SERVICE BULLETIN No.1153

COACH MODEL	: T2145 and C2045
BULLETIN TYPE	: Safety Recall Program – NHTSA campaign number 04V-424
MANUAL & SECTION	: Maintenance Manual: Chapter 7 - Steering Spare Parts Manual: Section 651209 Steering – hydraulic system
PARTS BOOK REVISION	: No
DATE	: December 3, 2004
SUBJECT	: Power steering line - inspection
TERMS & CONDITIONS	: Refer to the Warranty Information in this Bulletin.

Figure 2: Fitting crimp length L should be at least 0.944 inch

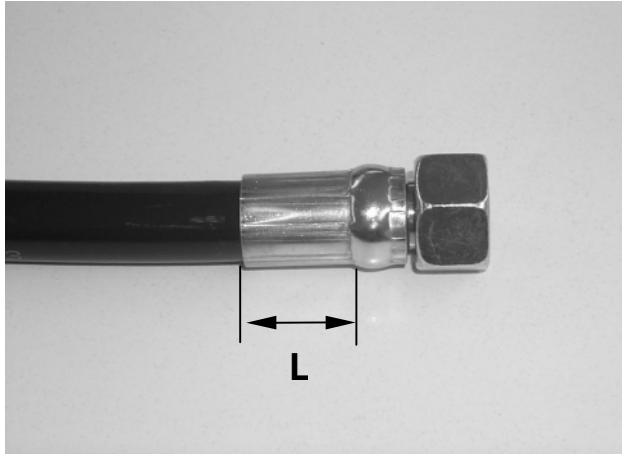
1. the crimp length of the affected hose fittings, which should be at least 0.944 inch (24 mm) as indicated in Figure 2.
2. the crimp diameter of the affected hose fittings, which should be 0.893 inch (22.7 mm) maximum as indicated in Figure 3.

1. a fitting with a crimp length *less* than the above-mentioned value (see Figure 4) should be put out of service.
2. a fitting with a crimp diameter *higher* than the above-mentioned value should be put out of service.

Figure 4: Hoses with fittings having a crimp length less than 0.944 inch and/or a crimp diameter greater than 0.893 inch should no longer be used

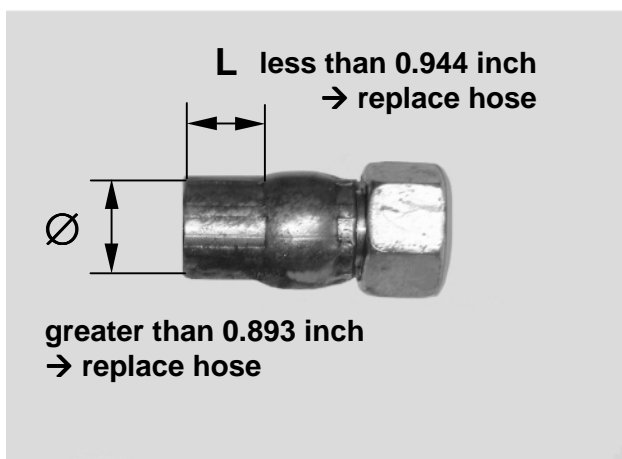
A new hose with properly installed fittings should replace the hose put out of service.

Figure 5: Behind rear engine compartment door - C2045 and T2145 w/ Detroit Diesel engine - pressure feed line at hydraulic pump. Check one crimp fitting.

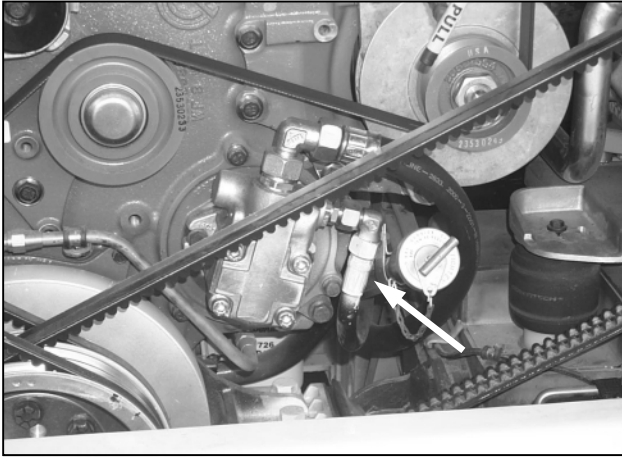
2) Referring to Figures 5 through 10, locate the crimp fittings.

Figure 11: Spare line duct at the front of the coach with new central tunnel line installed

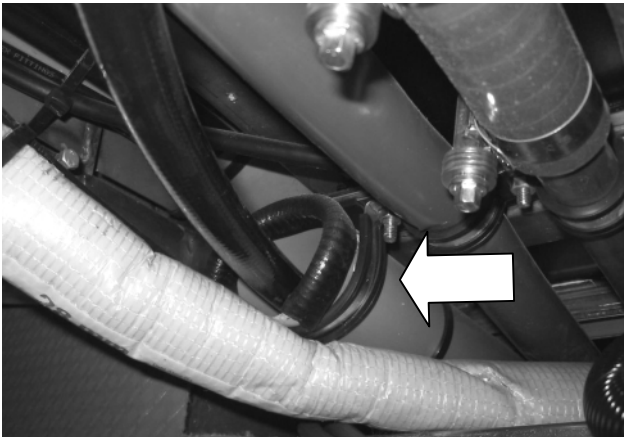
The procedure to replace the central tunnel line is similar to that of the engine compartment line. However, the faulty hose can be left in place and does not need to be removed from the coach. Proceed the installation of the new hose as follows:

- 1) After disconnecting the old central tunnel line from the engine compartment line at the rear, and the chassis to steering gearbox line at the front, blow it through with compressed air (30 psi maximum) while an assistant catches the fluid inside the line in a suitable container. Cap the line (using the plastic caps VH 637101760, which come with the new hoses) to avoid fluid spillage. Leave the line in place. Do add a label at both ends indicating that this line should not be re-used.
- 2) Run the new hose through the spare line duct above the fuel tank at the front (see Figure 11).
- 3) Next run the new hose along the old central tunnel line in the luggage compartment.
- 4) Finally, run the new hose to the engine compartment via the spare line duct above the drive and tag axles (see Figure 12).
